# Access Compliance Report

## Public Rights-of-Way

Intersection ID: 24051	Main Street: DEHAVILLAND_DR	Cross Street: SILVER_DART_PL	Location: NW
ADA ID: 52AB79EEB0D5	Ramp Type: PerpDiag	Initial Pass/Fail: Fail	Overall Compliance: No
Severity Score: 12.5			
Codes/Mitigation Info/Possible Solution		Field Measurements/Component Compliance

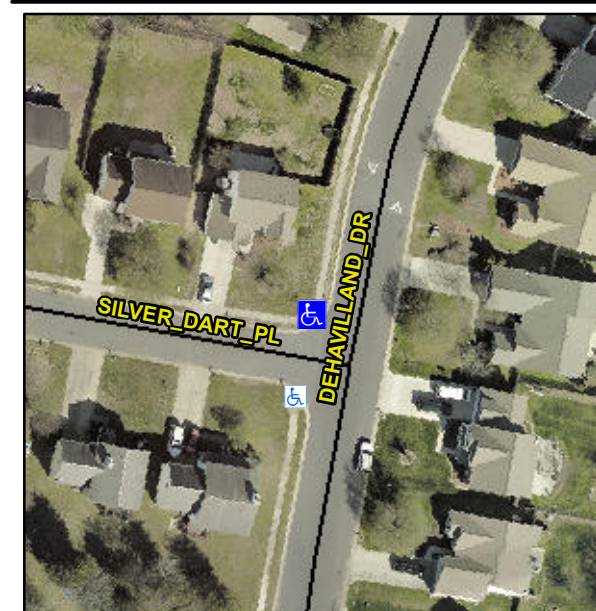
**Remove & Replace Curb Ramp With Two New Directional Ramps or Equivalent.**

**R304.5.3**

Compliance	Description	Data	Compliance	Description	Data
N/A	Ramp Length (in)	81.0	Yes	Ramp Slope (%)	6.1
Yes	Ramp Width (in)	66.0	No	Ramp XSlope (%)	5.1
N/A	Flare Type LT	N/A	N/A	Flare Type RT	N/A
N/A	Flare Slope LT (%)	N/A	N/A	Flare Slope RT (%)	N/A
N/A	Flare Traversable LT?	N/A	N/A	Flare Traversable RT?	N/A
N/A	Landing Length (in)	N/A	N/A	DWS Provided?	N/A
N/A	Landing Width (in)	N/A	N/A	DWS Contrast?	N/A
N/A	Landing Slope (%)	N/A	N/A	DWS Length (in)	N/A
N/A	Landing X Slope (%)	N/A	N/A	DWS Full Width?	N/A
N/A	Landing Curb? (Y/N)	N/A	N/A	DWS Offset (in)	N/A
N/A	Shared Landing?	N/A			
N/A	Gutter Ponding?	N/A	N/A	Gutter Slope (%)	N/A
N/A	Gutter Lip Ht (in)	N/A	N/A	Gutter X Slope (%)	N/A
N/A	Painted X Walk1?	No	N/A	Painted X Walk2?	No
	X Walk 1 Direction	To SW		X Walk 2 Direction	To SE
N/A	X Walk 1 Width (in)	N/A	N/A	X Walk 2 Width (in)	N/A
	X Walk 1 Slope (%)	0.3		X Walk 2 Slope (%)	2.8
	X Walk 1 X Slope (%)	0.5		X Walk 2 X Slope (%)	2.9
